SERVICE LETTER

No. SL-NG-2-22

Subject: FWD Tail Spring Attachment Bracket

Aircraft affected: EXTRA NG: S/N NG001 through NG041.

Fig.: Front attachment tail landing gear

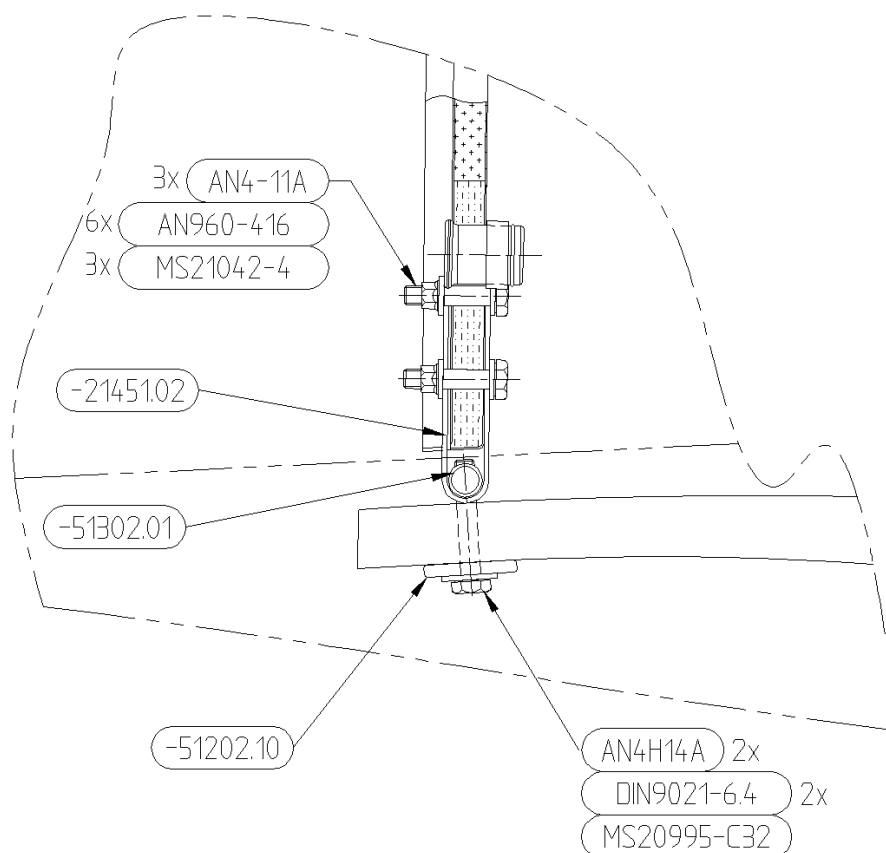
Purpose: A failure of a forward attachment bracket (PN EX-21451.02) of the tail landing gear spring during landing roll at taxi speed was reported on one airplane.

A proactive design change of the forward attachment bracket is made available to customers on demand. This improved bracket can be used as direct exchange part/replacement of the original bracket installed.

1. Remove Tail Spring as per chapter 32-10-03 of the EXTRA NG Maintenance Manual (AMM).
2. Remove 3 bolts (AN4-11A) connecting the original fwd tail spring bracket (EX-21451.02) to the fuselage, then remove bracket. Keep bearing shaft (EX-51302.01).

3. Apply grease (MIL-PRF-81322G or equivalent) to the bearing shaft (EX-51302.01) and insert into the improved bracket (EX-21451.02, Version A).

4. Reinstall the improved bracket (EX-21451.02, Version A) into fuselage. Use new locknuts (MS21042-4) and tighten bolts according to standard torque values (see chapter 20-10-03 of AMM).
5. Reinstall tail spring as per chapter 32-10-03 of the AMM. Secure the two bolts (AN4H14A) at the forward bracket with safety wire (see Figure above and Figure 3 in Chap. 32-10-04 of the AMM).
